Subject: Response to Request for Additional Information (RAI) Letter No. 4 –
Exelon Early Site Permit (ESP) Application for the Clinton ESP Site
(TAC No. MC1122)

Re: Letter, U.S. Nuclear Regulatory Commission (N. V. Gilles) to Exelon
Generation Company, LLC, (M. Kray), dated July 26, 2004, Request for
Additional Information Letter No. 4 – Exelon Early Site Permit
Application for the Clinton ESP Site (TAC No. MC1122)

Enclosed, as requested in the referenced letter, are responses to the requests for additional information (RAIs) associated with the meteorology portion of the Exelon Generation Company, LLC (EGC) ESP application.

Figure 23.4 The maximum wind speed expected at a probability level of 10^{-4} (once in 1,000,000 years). The isopleths for wind speed are after Fujita (1987), determined using UC data 1916-1985. The base map is of Project significant tornadoes, 1916-1989.

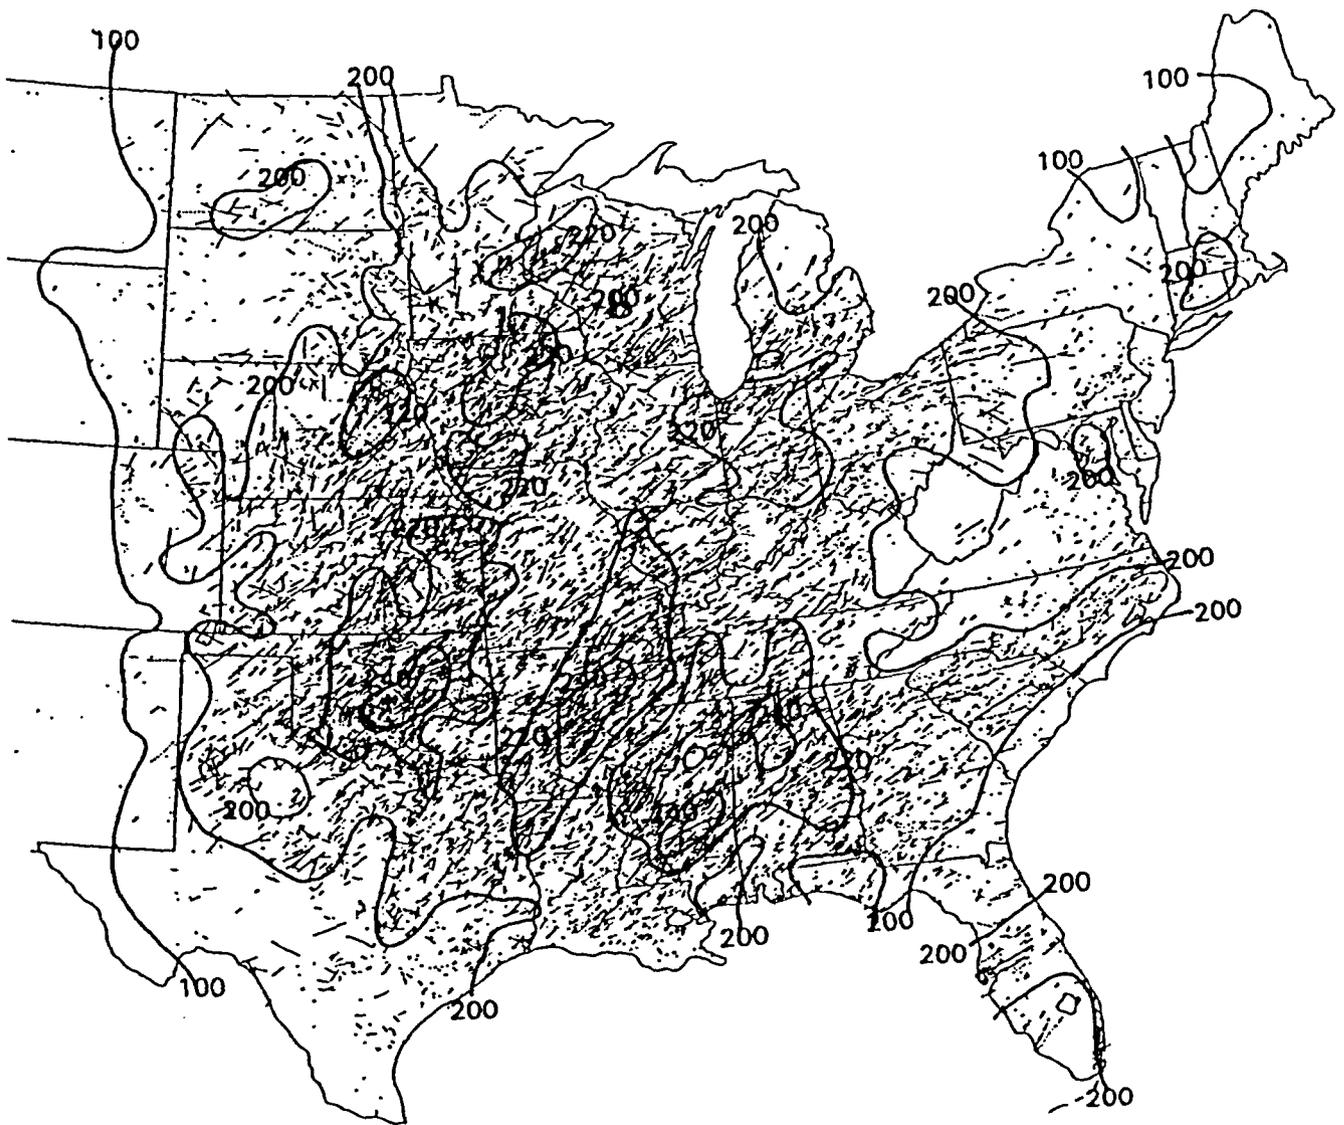
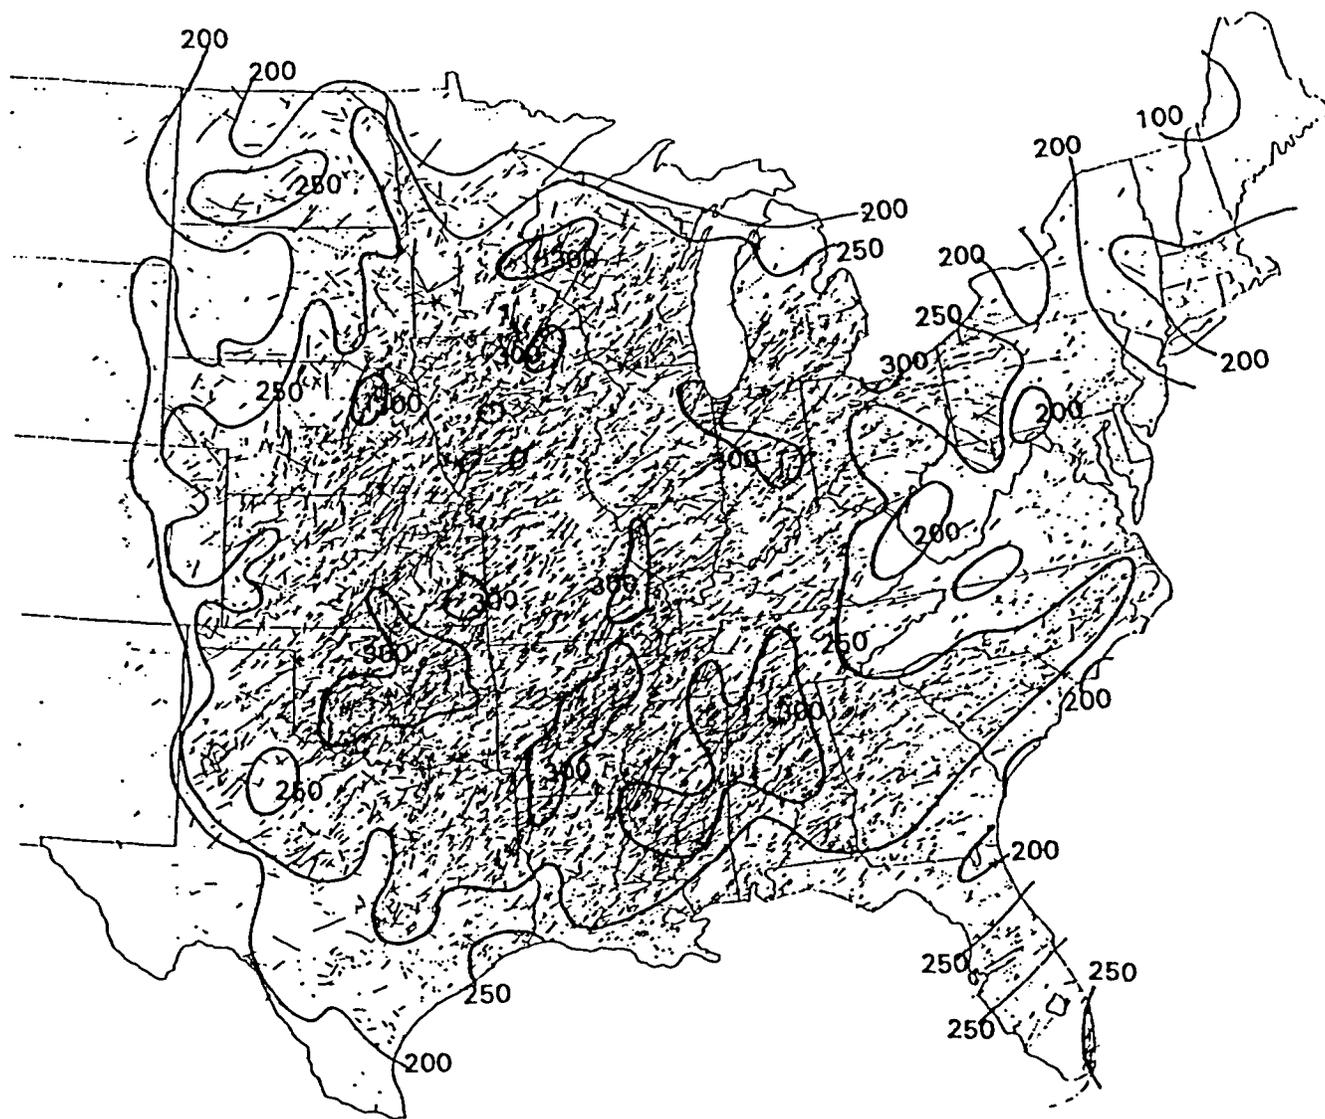
ESP applicants are not required to use either RG 1.76 or the staff's interim position on design basis tornado wind speed, although they may do so since both are staff-accepted approaches. ESP applicants may use any design-basis tornado wind speeds that are appropriately justified. However, the staff does not believe that citing SECY-93-087 (or any document related to design certification) is adequate justification for use of 300 mph. In particular, Figure 30 of NUREG/CR-4461 shows a 10^{-7} probability of occurrence of wind speed of 327 mph for the Clinton ESP site. Please provide a safety justification for choosing 300 mph as the site characteristic maximum tornado wind speed for the Clinton ESP site.

Additional justification for a site-specific 300 mph tornado wind speed site characteristic is provided in a 1993 published analysis of tornadoes (Grazulis, 1993) from 1680 through 1991 conducted by *The Tornado Project* headed by Thomas P. Grazulis. This analysis indicates that the maximum wind speed expected at a probability of $10E-6$ (i.e., once in 1,000,000 years) at the Clinton site will be between 200 and 220 mph (Figure 23.4 in Grazulis, 1993). This analysis also indicates the maximum wind speed expected at a probability of $10E-7$ (once in 10,000,000 years) at the Clinton site will be between 250 and 300 mph (Figure 23.5 in Grazulis, 1993). Thus, this data indicates a Clinton site characteristic of 300 mph or less even using the requested 10^{-7} recurrence interval. A copy of the referenced Figures is provided as an attachment to this response. This information and reference will be incorporated into the SSAR in a future revision.

These parameters are believed to be relatively consistent with expected conditions associated with potential worst-case tornadoes, namely the F4/F5 class of tornadoes. In addition, a site-specific 300-mph tornado wind speed site characteristic is consistent with a 1993 published analysis of tornadoes (Grazulis, 1993b) from 1680 through 1991 conducted by The Tornado Project headed by Thomas P. Grazulis. This analysis indicates that the maximum wind speed expected at a probability of $10E-6$ (i.e., once in 1,000,000 years) at the Clinton site to be between 200 and 220 mph (Figure 23.4 in Grazulis, 1993b). This analysis also indicates the maximum wind speed expected at a probability of $10E-7$ (once in 10,000,000 years) at the Clinton site to be between 250 and 300 mph (Figure 23.5 in Grazulis, 1993b). Thus, this data indicates a Clinton site characteristic of 300 mph or less even using a 10^{-7} recurrence interval.
